**Freightliner
 Service Bulletin**

Effective December 3, 2013 DAVCO Fuel Pro and Diesel Pro preheaters were upgraded to positive temperature coefficient (PTC) 195w heater technology. This technology uses less amperage during operation, however there is an "in rush" current spike that exceeds 20amps for up to 5 seconds at initial start-up. Due to this "in rush" current spike the M2, 108SD, and 114SD chassis electrical control module (ECM) may activate fault code SA 33 SPN 6897 FMI 6 when the engine is first started.

Fig. 1, DAVCO Preheater Installation

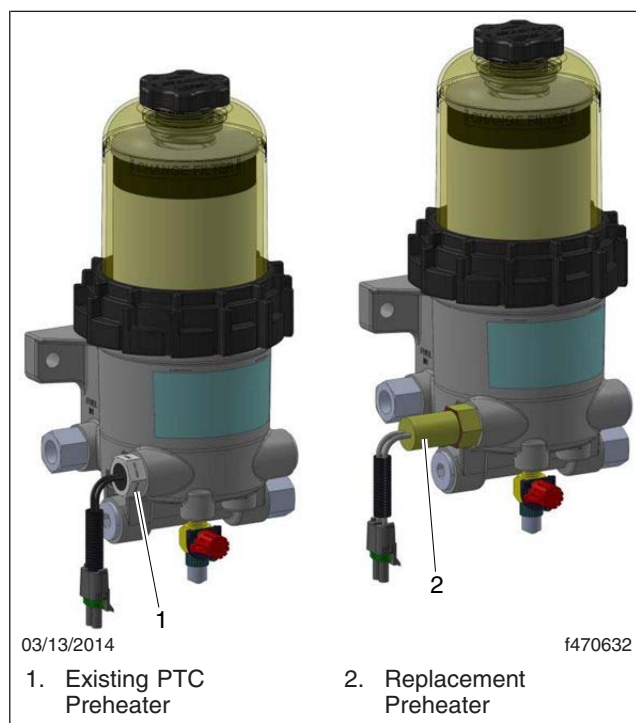
To resolve this fault code, replace the DAVCO fuel/water separator preheater. See [Table 1](#) under "Parts" for the correct replacement preheater.

1. Park the vehicle on a level surface, shut down the engine and set the parking brake. Chock the tires.
2. Drain the fuel from the fuel filter into an appropriate container.
3. Clip the zip-ties holding the wire harness in place.
4. Disconnect the wire harness.
5. Remove the PTC style preheater.
6. Install the replacement preheater.
7. Connect the wire harness.
8. Secure the wire harness in place with zip-ties.

9. Prime the fuel filter.
10. Start the engine and check for leaks. Repair as needed.
